ANALYSIS OF A & M 24"

PURGE VALVE

BIG ROCK NPS

REPORT NO. JHA-79-138

### 3.2 DISC

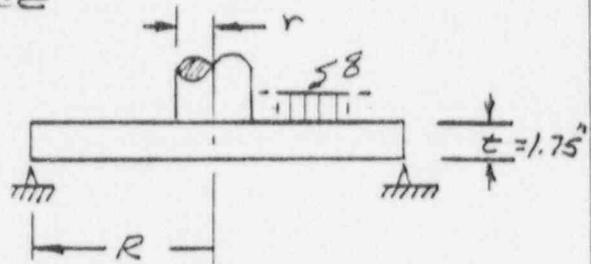
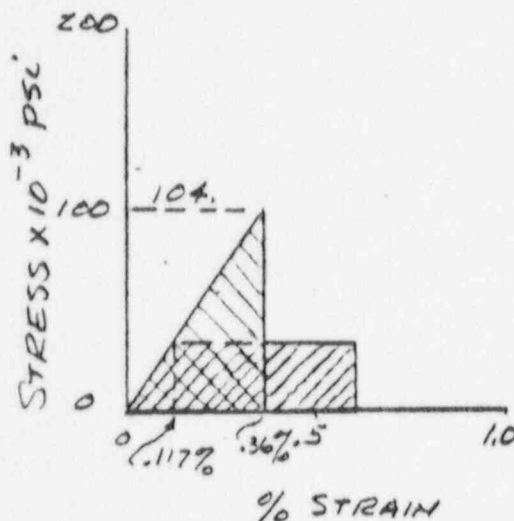
Detailed Comments on John Henry Report JHA-79-1381. Page 10 - Disc strain due to impact on the seat

The disc strain calculation apparently assumes the disc is built in at the disc post. Actually, the post is threaded into the disc and seal welded. It appears the "built-in" assumption is not realistic. Furthermore, the strain is calculated in the disc, but no evaluation is made of the weld which is at the point of highest strain. The plastic strain calculation is made by assuming that the elastic-plastic strain energy absorbed at the point of highest strain is the same as the strain energy calculated by the elastic analysis. This assumption is not valid since it does not account for the redistribution of strain energy when a part of the disc is plastic. The result is an unconservatively low strain. The loading model used for calculating disc strain ignores the concentrated load from the disc post and disc arm.

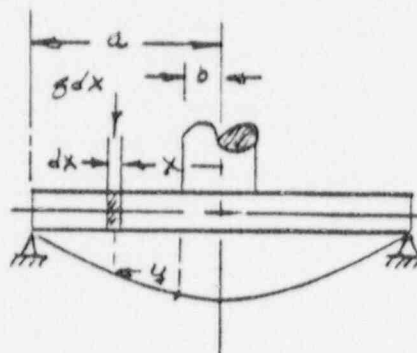
2. Page 11 - Disc energy

It is not clear that the cosine shape assumed for the disc distortion is valid. It is not consistent with the formula used for disc strain. The assumed deflection and the strain energy formula are based on elastic analyses of the disc. Since the disc goes plastic, the energy calculation is not correct.

### 3.3 ARM EVALUATION (AM 8258-C)

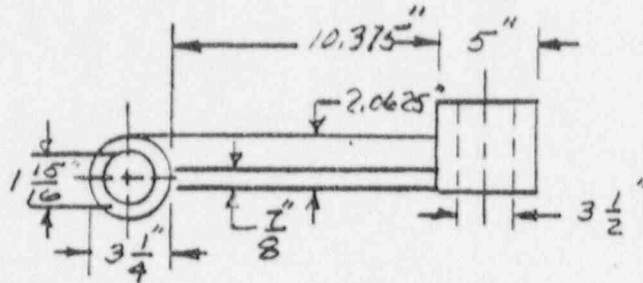
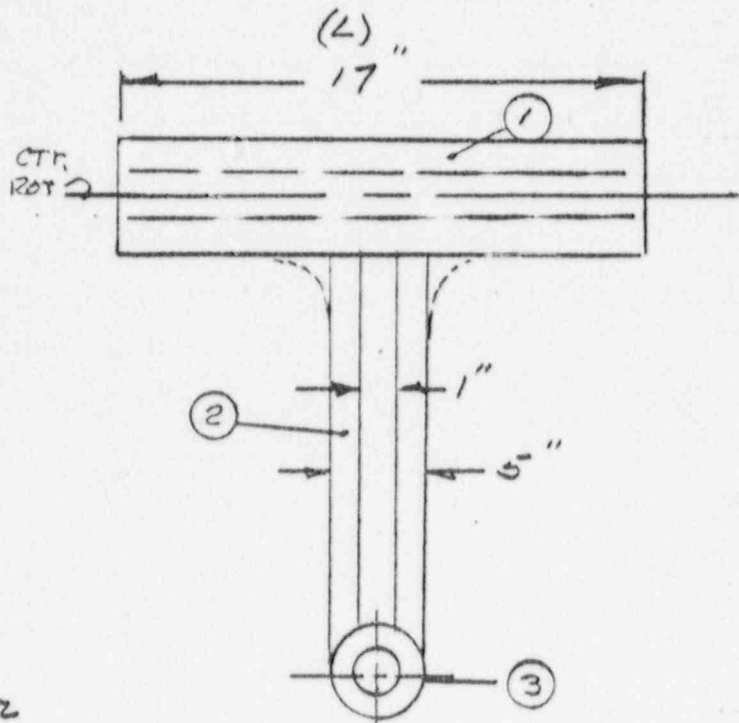
4. Page 24 - Disc arm strain

The elastic strain is calculated. Plastic strain and distortion should be calculated. The deceleration of the end of the arm at the disc center could be used instead of assuming a rigid impact.

### 3.4 SHAFT EVALUATION (20329-B)

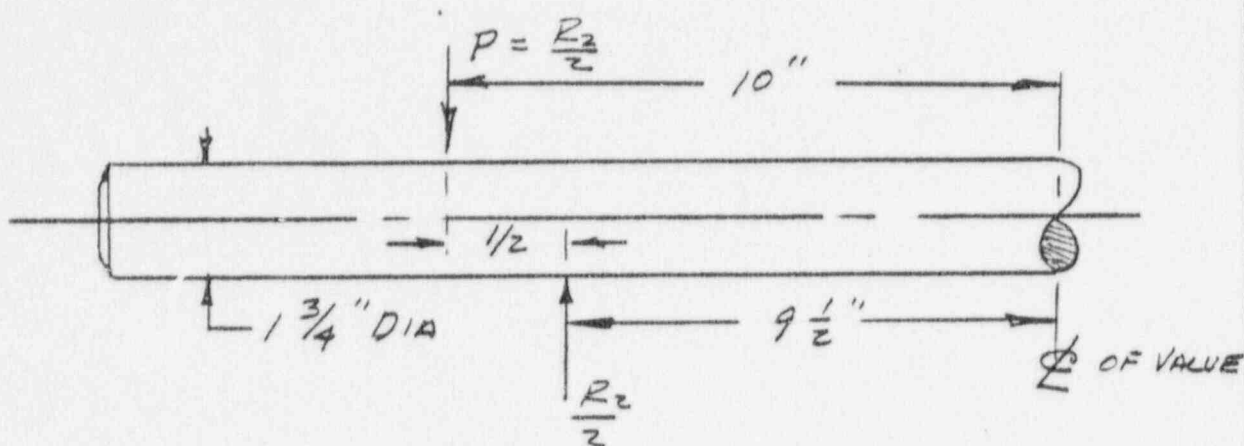
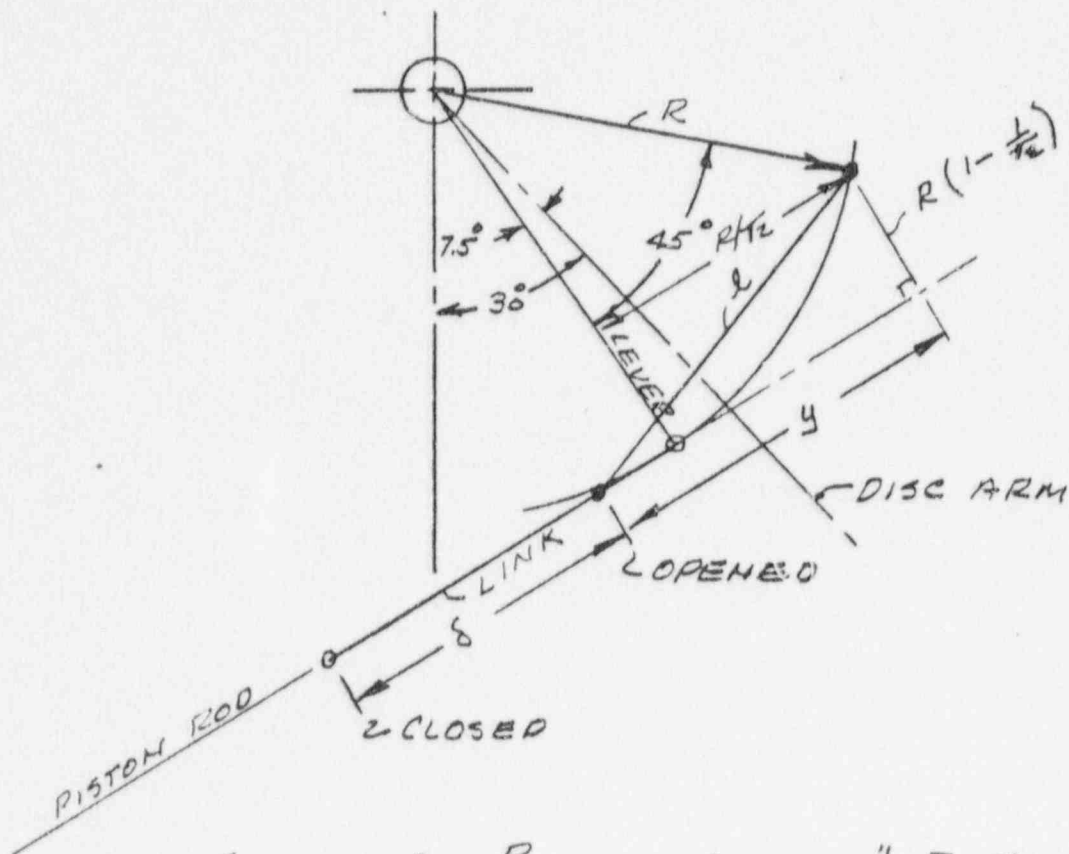
5. Page 26 - Shaft stresses

The shaft torsional moment is incorrect. The moment used is the moment at the edge of the hub on the lever arm; the moment about the shaft centerline should be used. This same comment applies to the shaft key analysis on page 37.

The shaft stresses from the operator forces should include the transverse shear and bending stresses.

The shaft strain is calculated elastically; the plastic strain should be calculated.

The strain concentration at the shaft keys should be evaluated.

PIN-SHEAR

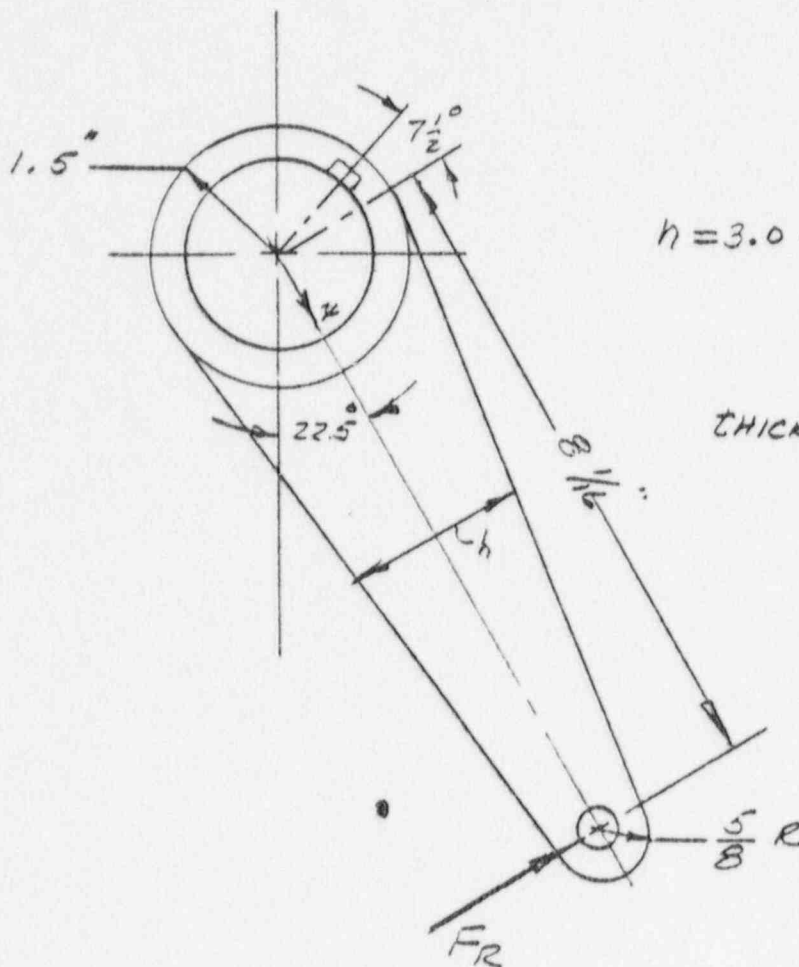
7. Page 33 - Operator pin shear

The value used for the force on the pin is one-half the correct value.
